HISTORIC DISTRICT COMMISSION

CERTIFICATE OF APPROPRIATENESS

Application Number: HDC2025-00544

Project Address: 97 Arden Park Issued to: Timothy Flintoff Jr.

1 EAST ELEVATION

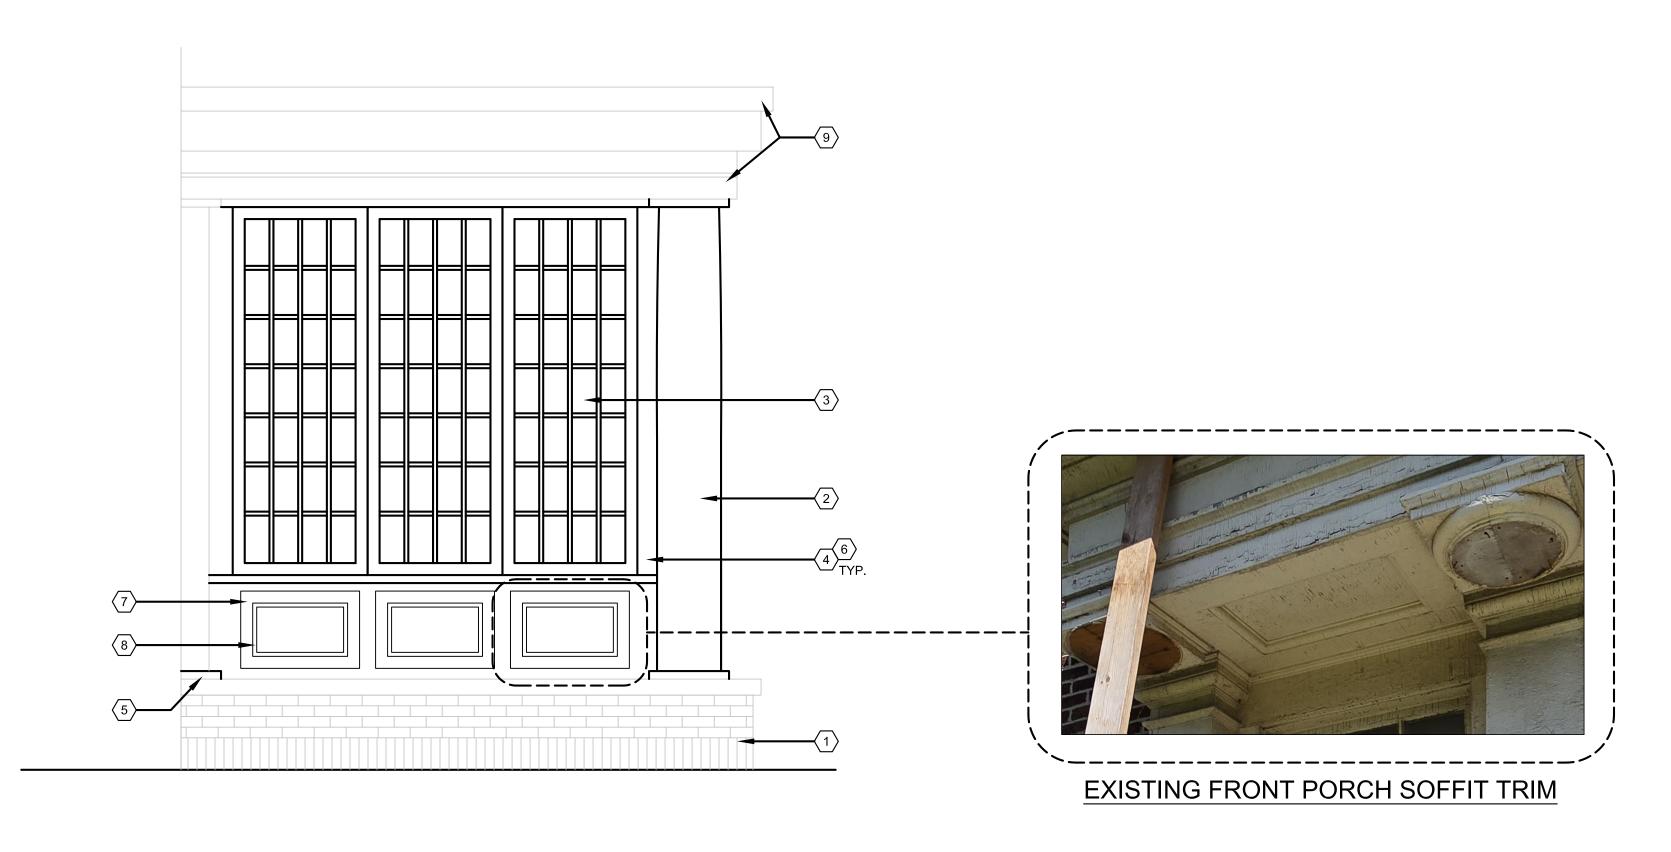
- For the east bay window replacement, applicant will submit final muntin pattern and placement (upper sash only or both sashes) for staff review and approval before work begins.

Sheet Title : ENCLOSED PORCH EXTERIOR ELEVATIONS

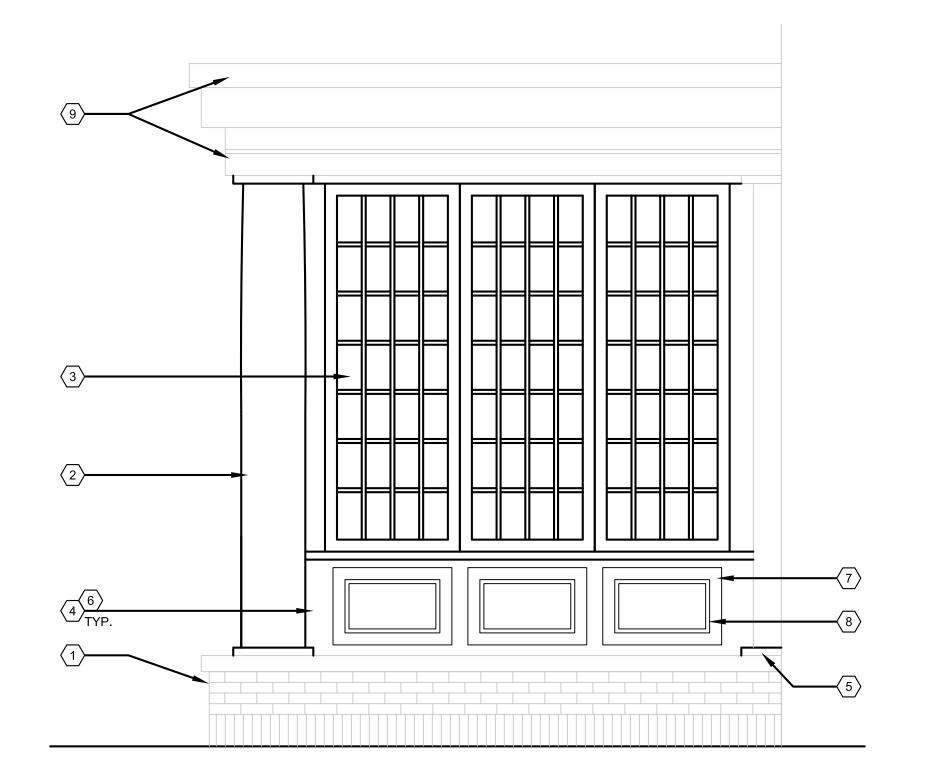
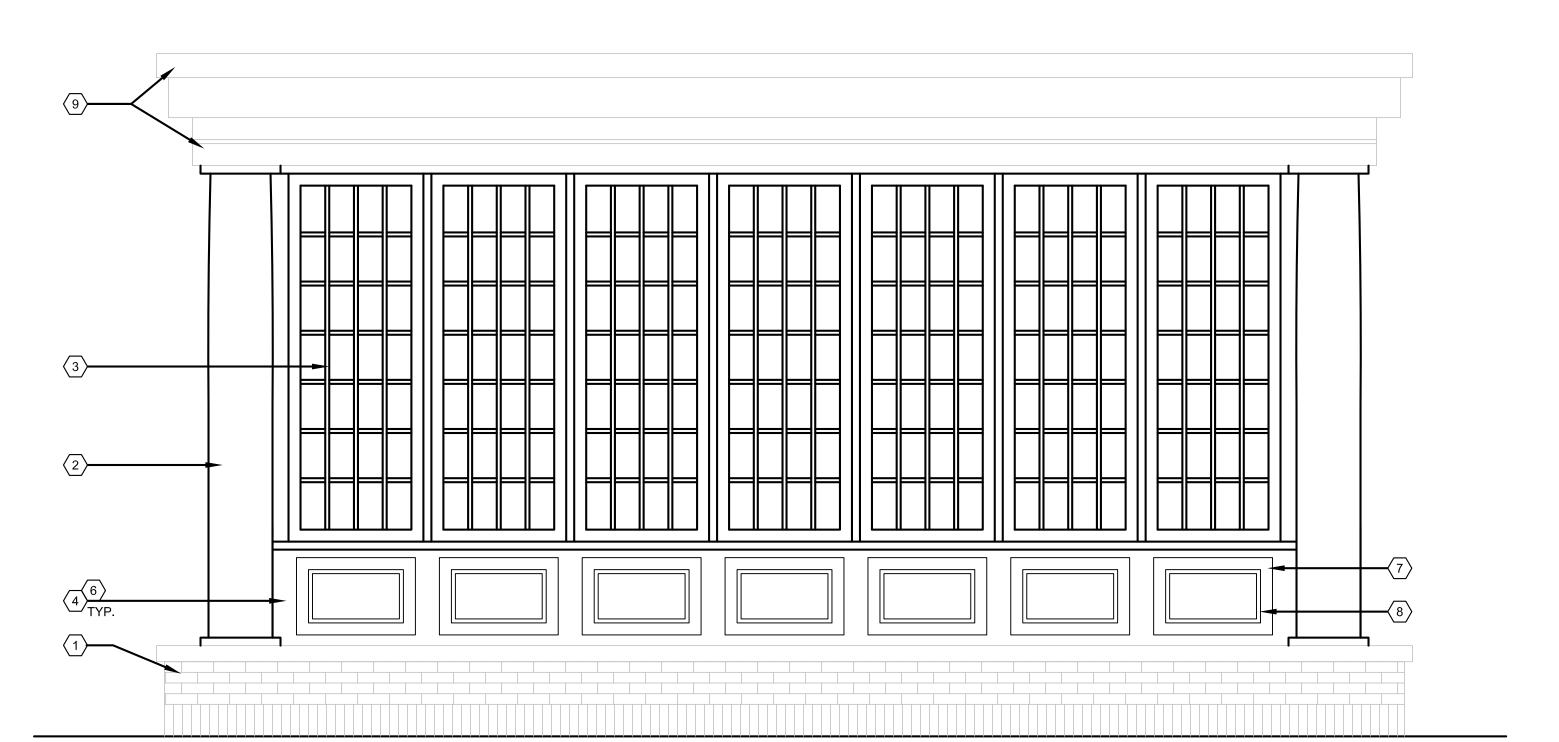
- The west enclosed porch's entablature must match that of the front portico. Applicant will provide detailed drawings of the entablatures of both the historic front portico and the new proposed west porch to staff for review and approval.

Sheet Title :
REAR PORCH
SECTION + ELEVATION

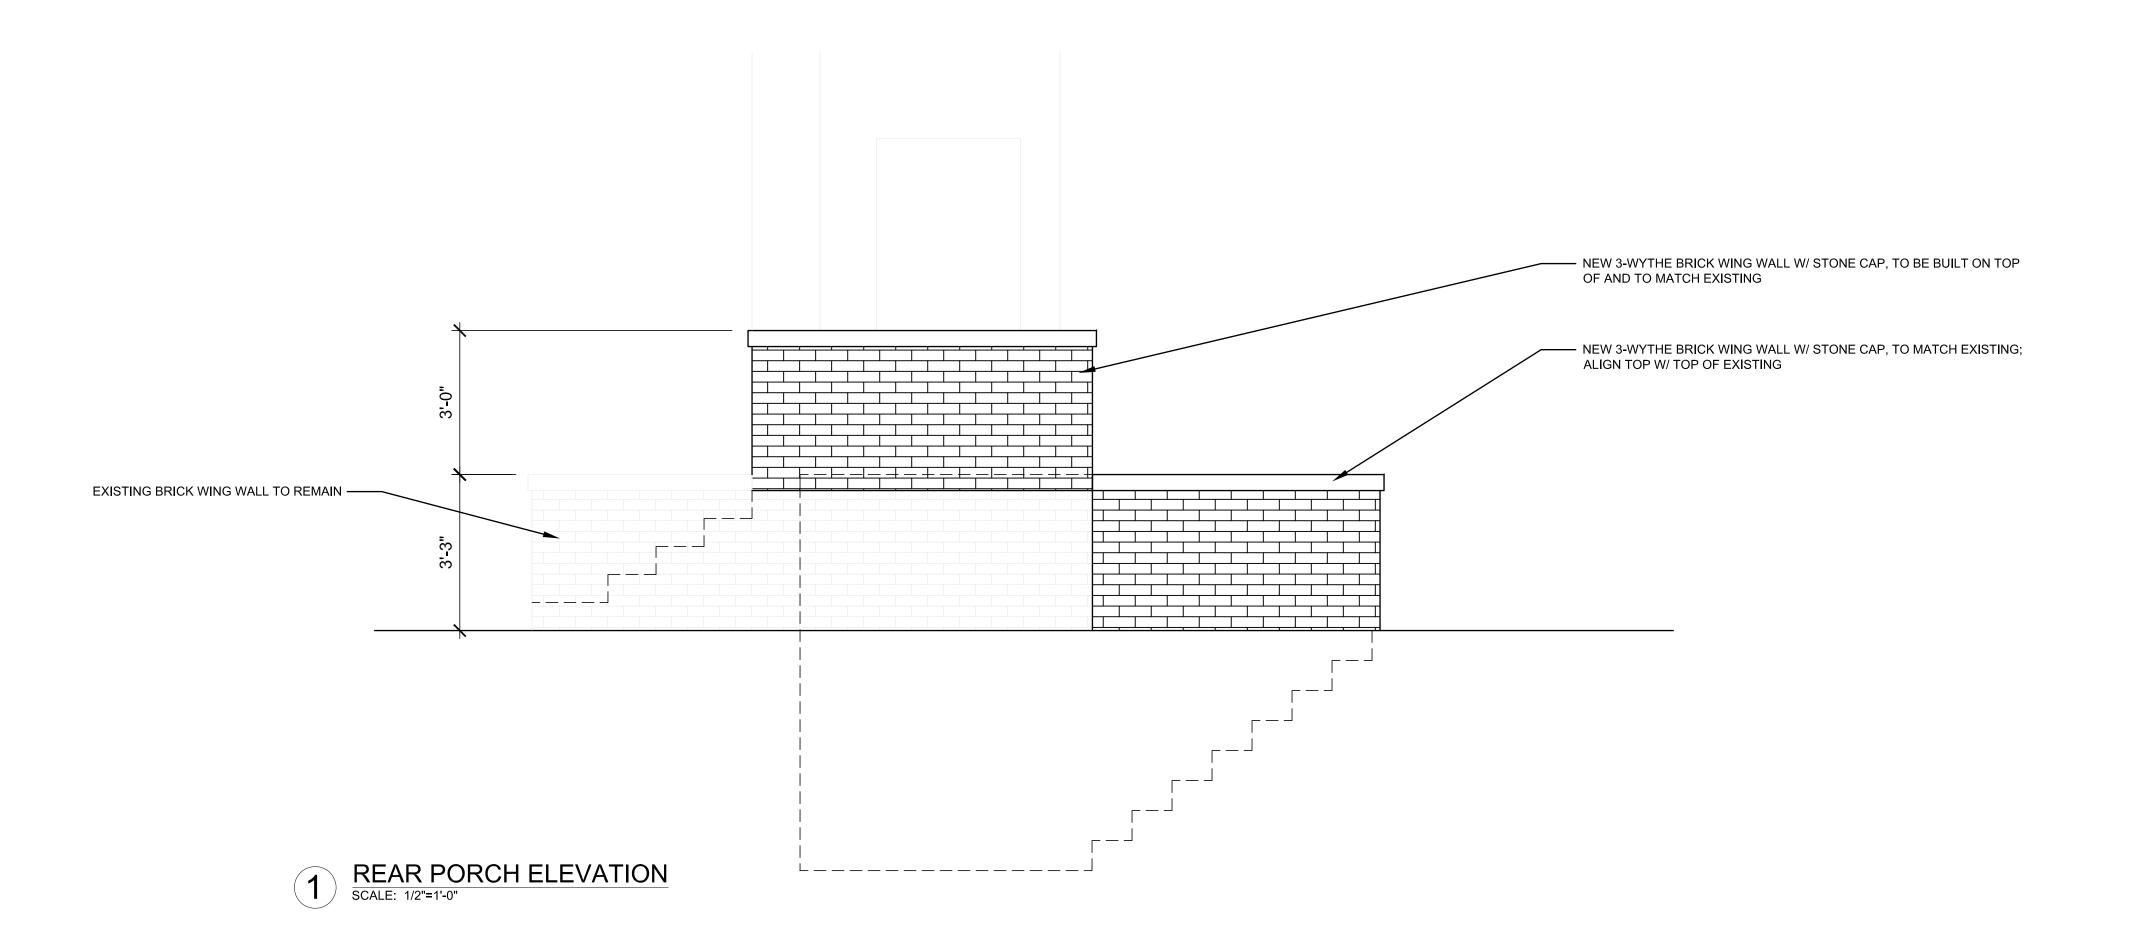
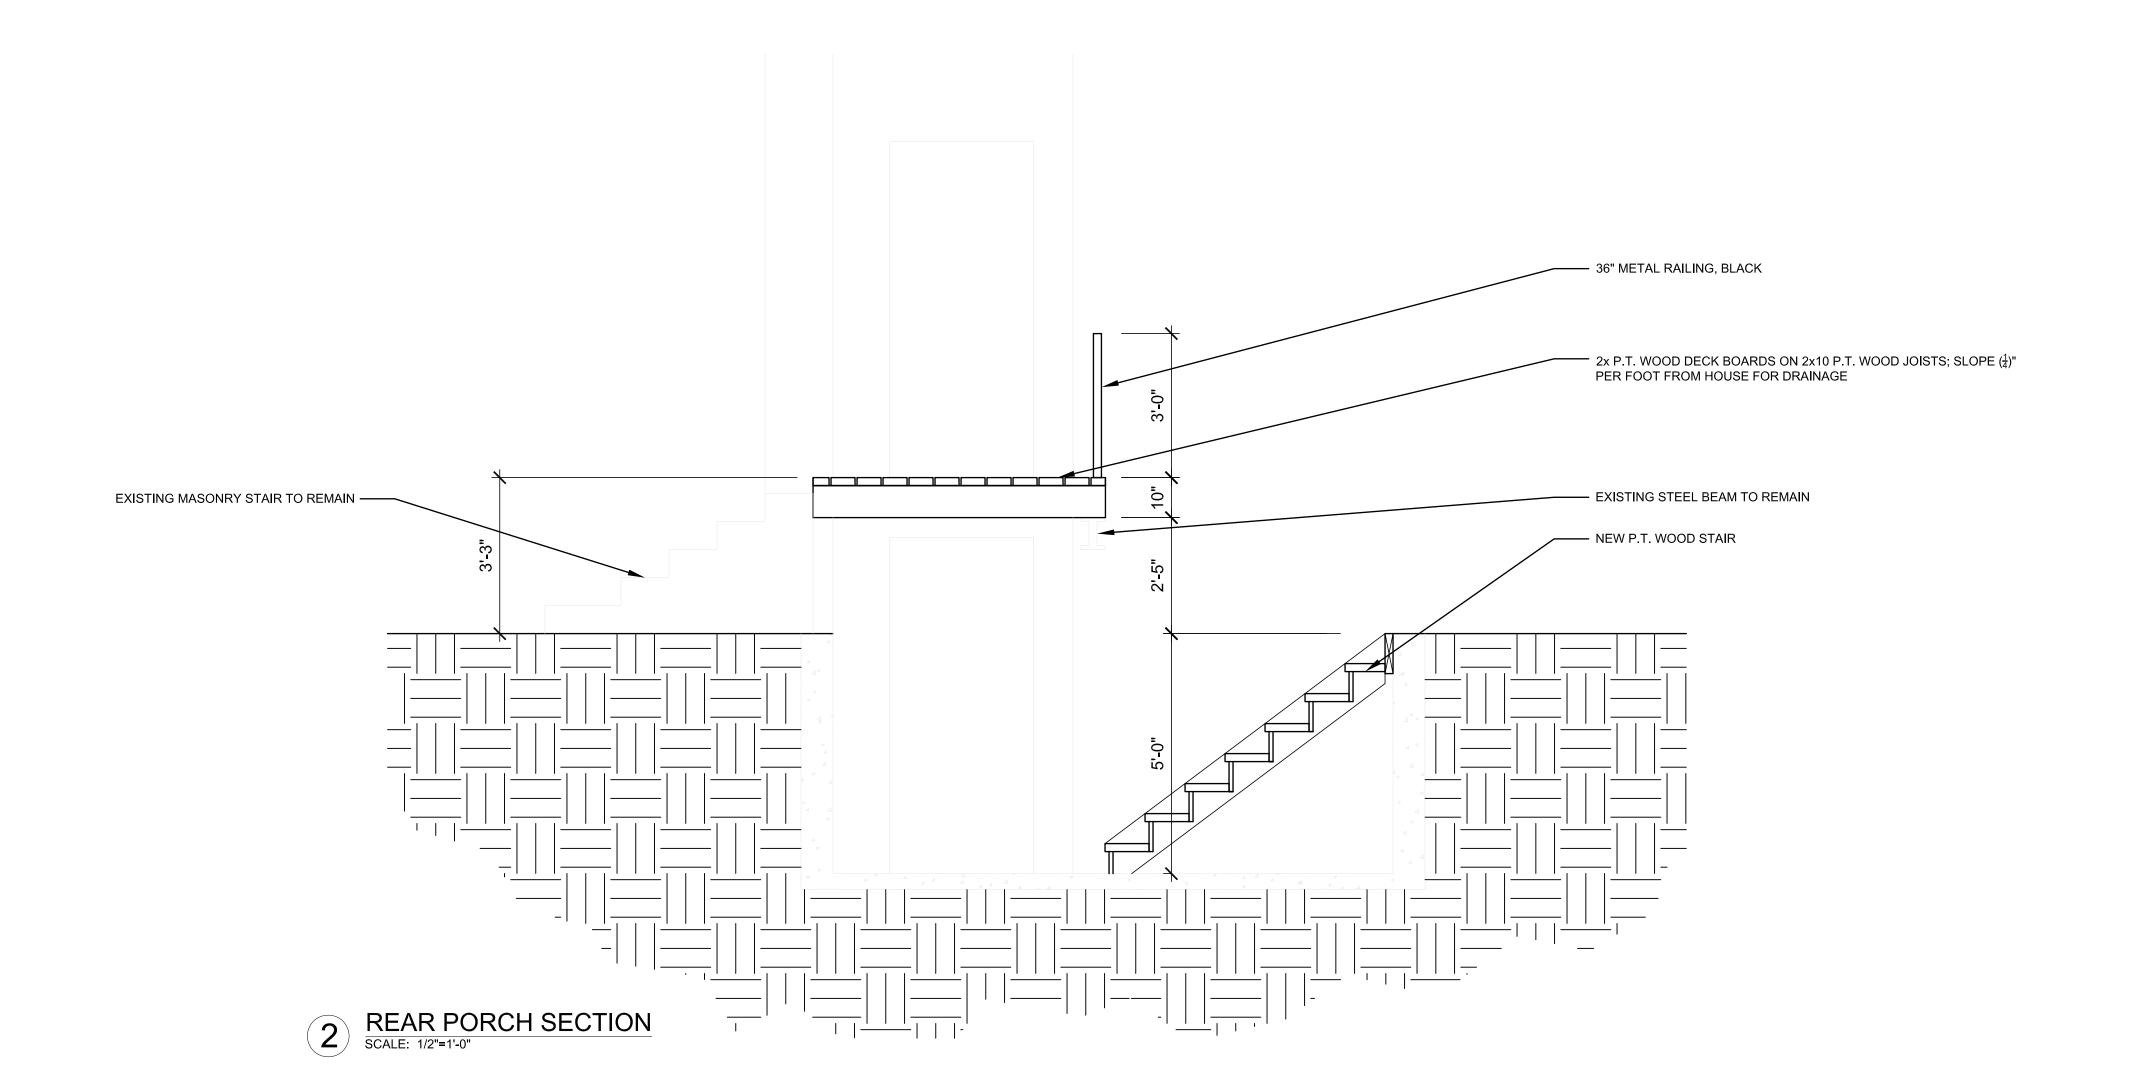
- On the rear porch, any pressure-treated wood used will be painted when cured.
- For the rear porch, a different rail will be submitted for staff review and approval.
